PRODUCT CHANGE NOTIFICATION

PCN #: 2023-N001
Issue Date: 2023-12-07

E-Switch Series/ Part No affected: TL6340 series	Part /Series Description: TL6340AF160Q

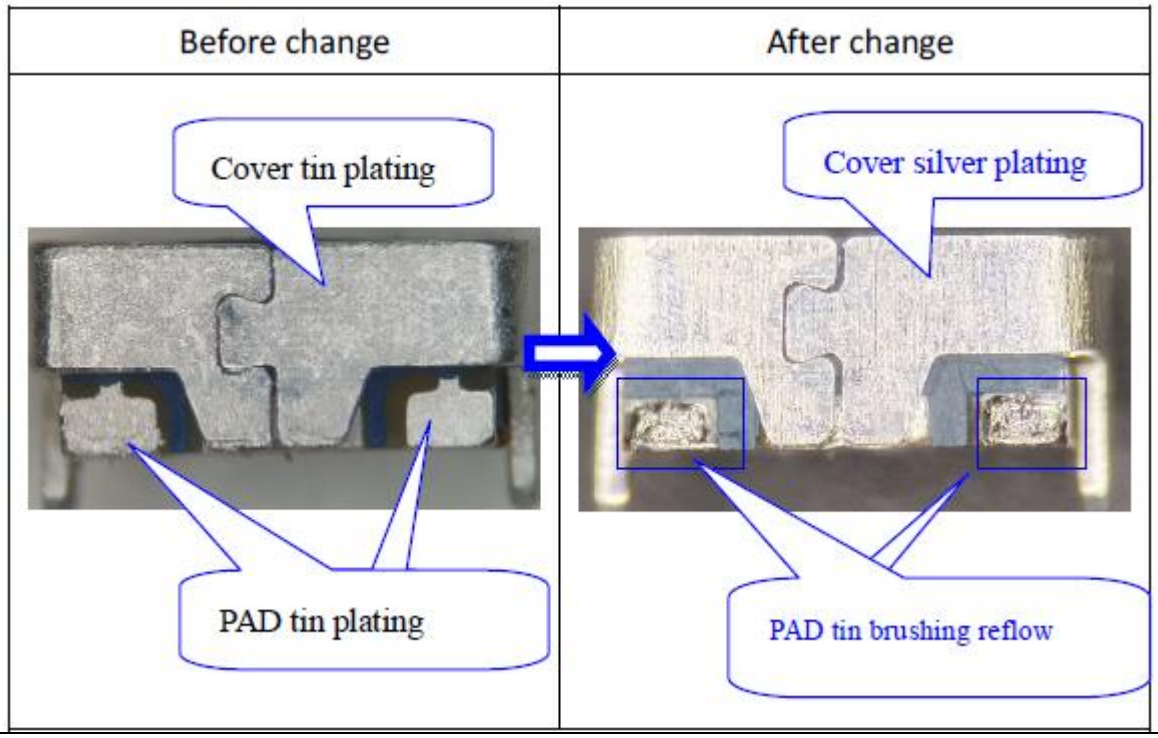
1. Long lead times for tin plating. Our primary supplier no longer provides a tin plating process.

The top cover plating will change from tin plating to silver plating, and the base PAD plating will change to a tin brushing process. Silver plating for the top cover is a widely adopted industry process and will not cause any functional impact.

Immediate. Date codes after Jan 1st 2024 will have the Silver Plating.
